- 1) *We encourage the dRICH group to follow the recommendations from the July 2023 PID review.*

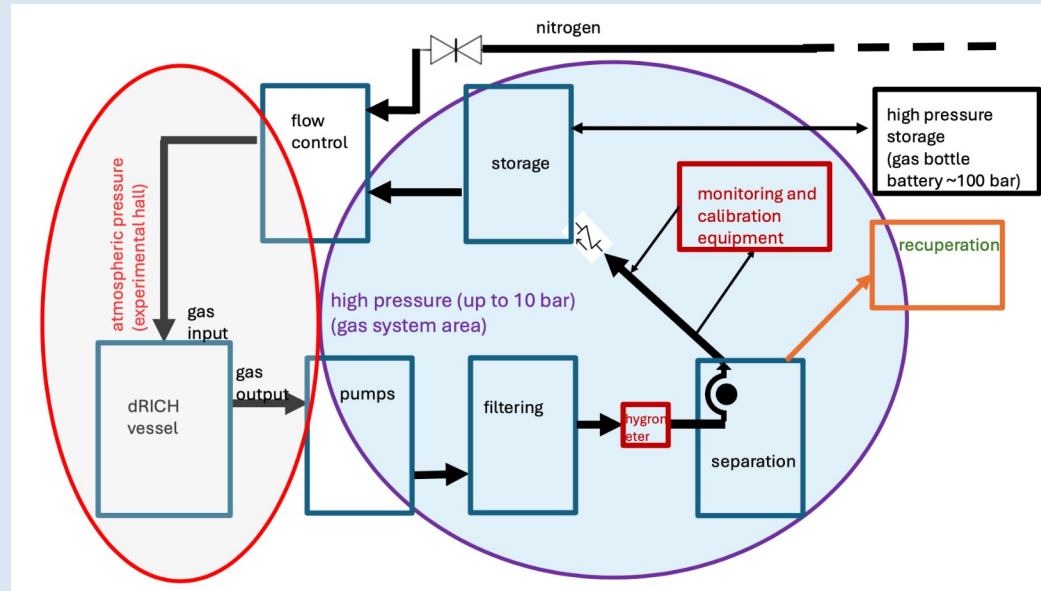
- 3) *It is important to understand the aerogel quality issues and give feedback to this manufacturer in order to allow time for the production of aerogel which meets the requirements of the detector.*

The quality issue has been solved by an optimization of the refractive index n (slide 6*). In accordance with the manufacturer, we now target $n=1.026$ and move to the tile dimension optimization (slide 7*). The target is to reach BELLE-II standard (18 cm side) in 2024 and, possibly, CLAS12 standard (20 cm side) in 2025.

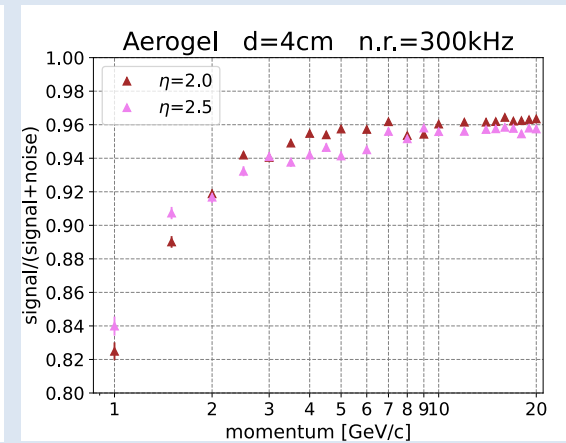
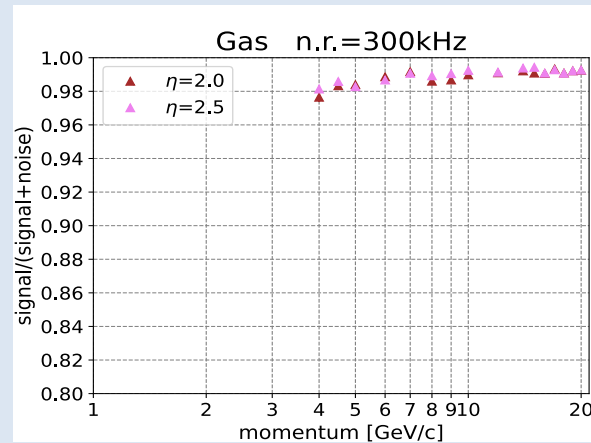
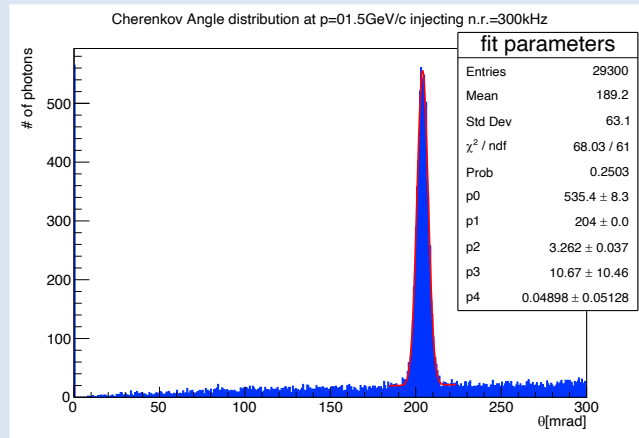
- 5) *To address concerns with multiple track PID, we recommend the implementation in the simulation of the expected backgrounds from the accelerator and study performance in the presence of overlapping tracks.*

This task is ongoing. We implemented in ePIC simulations a model for the SiPM dark count background: an example of worse-case scenario study was presented at the ePIC R&D Day in March '24 and is reported in the figure below (at nominal refractive index $n=1.02$). We also implemented the measured optimized aerogel parameters in order to get a proper signal over background ratio. At the same time, we initiated a study of the accelerator background as part of the dRICH event tagging effort to reduce the DAQ data rate (slide 27*). Preliminary results have been discussed at the ePIC Meeting in Lehigh (summer '24).
